Job Name: Waterfront Square, Reading

Note No: TN008

Subject: Transport Statement Addendum and Response to RBC Highway Comments

Extract from **Drawing 4012-ASA-XX-GF-DR-A-0200** showing the updated cycle storage.

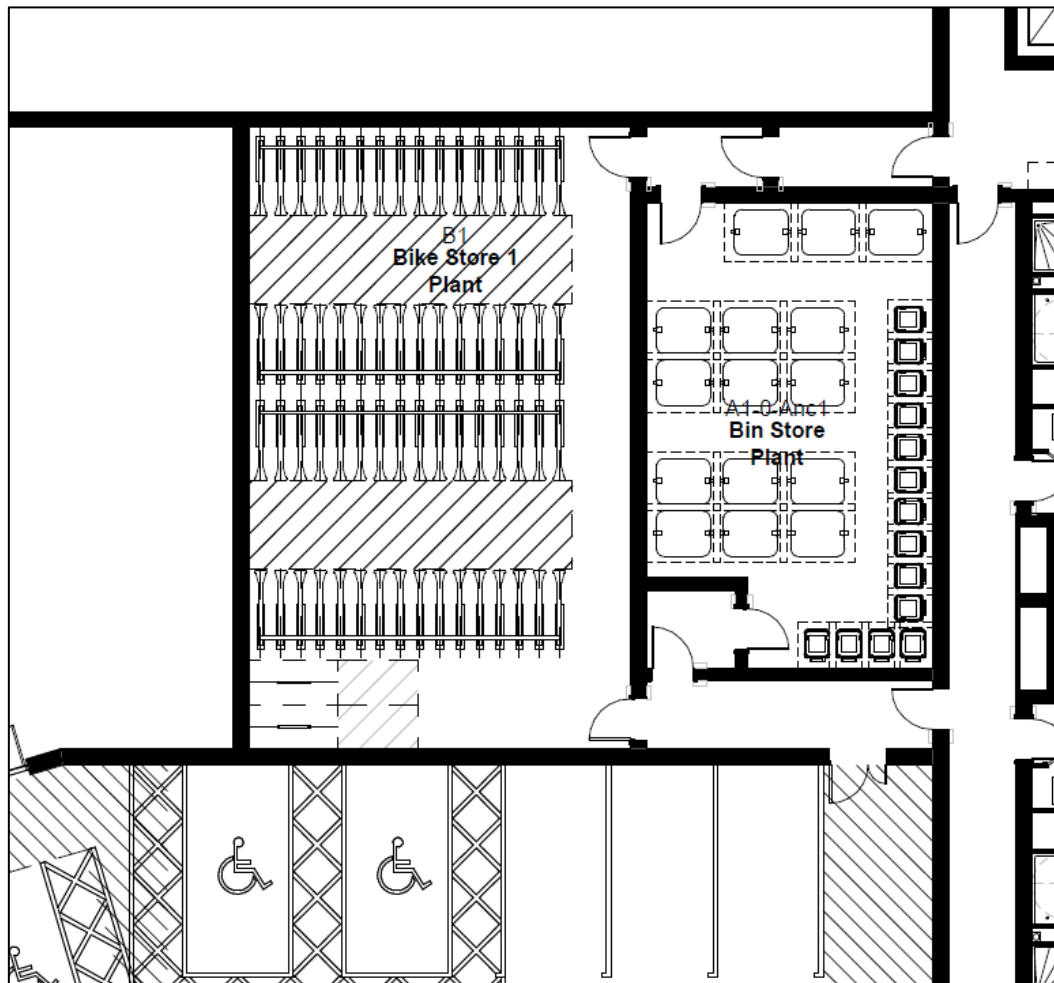
As part of the amended scheme, the western façade of the development has been moved further from Norman Place by 1m, this is in response to engagement with RBC and benefits the width of the proposed footway/cycleway and visibility from to access to the car park to the shared footway/cycleway. The scheme has also improved the public square by increasing its size.
